Addendum to Environmental Noise Report dated March 12, 2025

Proposed Industrial Development Highway 10 and Highway 407

City of Mississauga Our File: 14-064-02

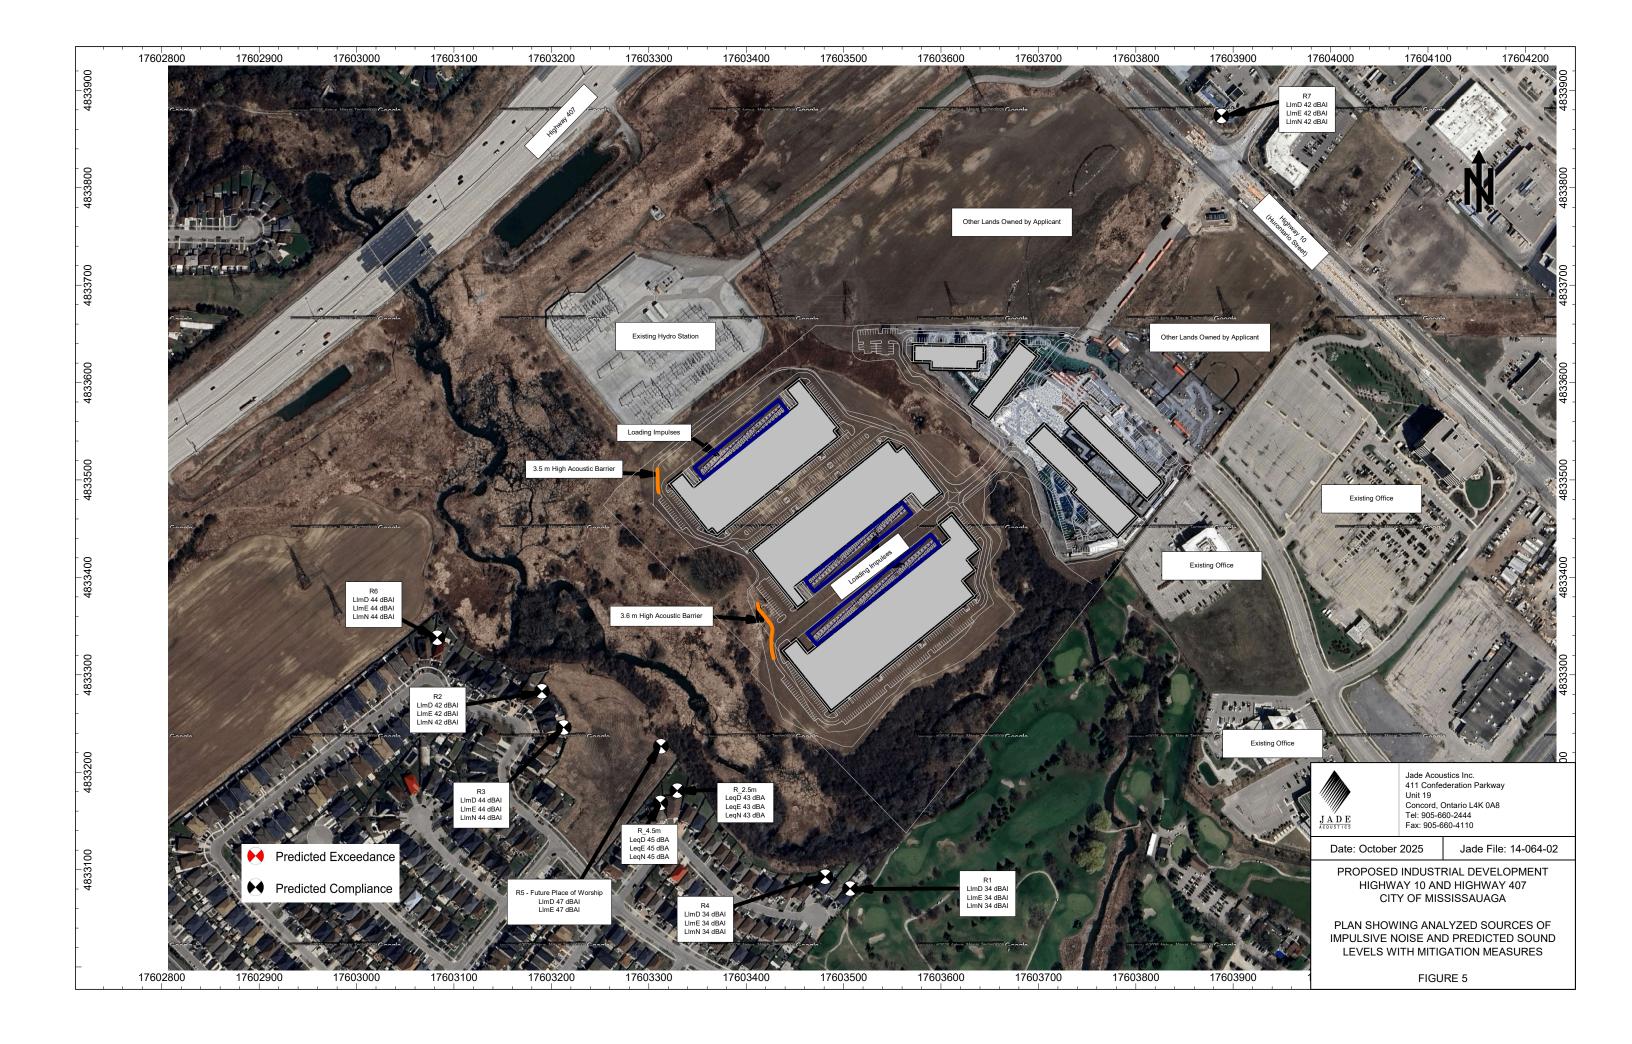
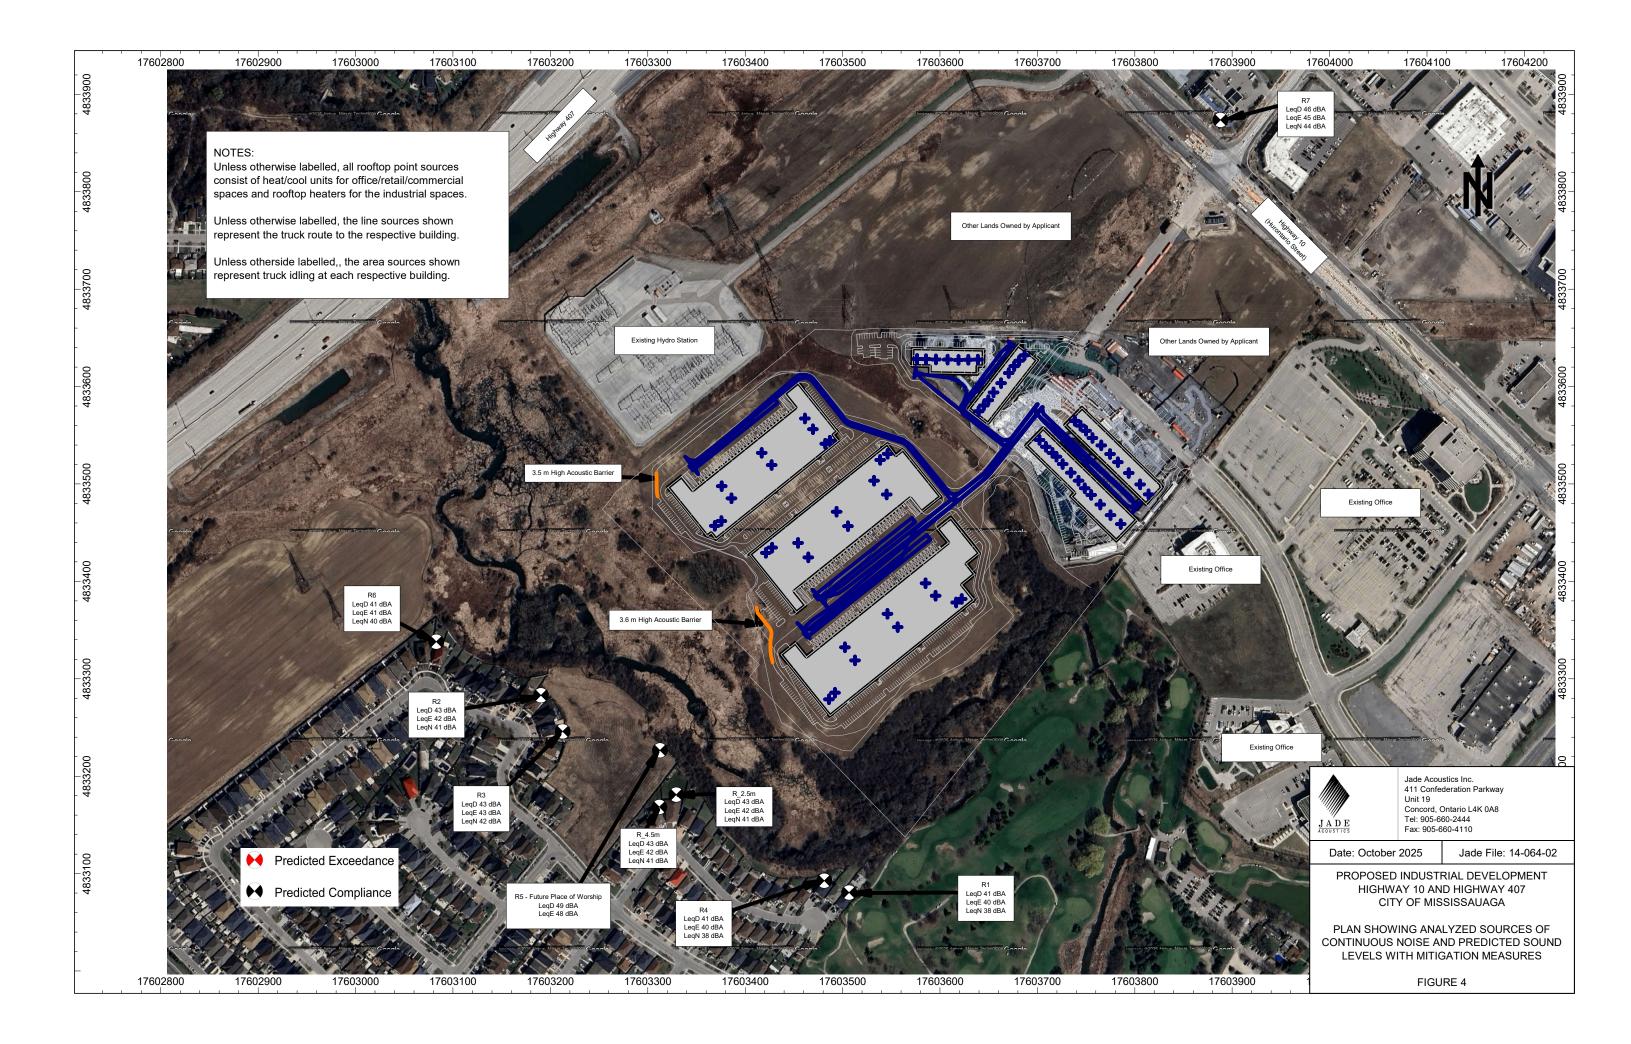
Please revise the report to address the following;

- (a) Provide a table depicting a range of barrier heights and corresponding mitigated sound levels.
- (b) Provide typical cross-sections for all the acoustic barriers (including fence returns) to be implemented at this site to control noise levels."

- a) The acoustic analysis has been updated as presented in the Addendum to Environmental Noise Report letter dated October 21, 2025 to address the revised building designs and updated site plan. The proposed acoustic barriers to address the base building on-site stationary noise sources result in predicted compliance with the applicable sound level limits at the neighbouring proposed and existing noise sensitive receptors; therefore, no further details regarding barrier heights are required regarding demonstrated sound level limit compliance.
- b) Typical cross-sections of the acoustic barriers will be prepared by others, as coordinated with the updated acoustical analysis.
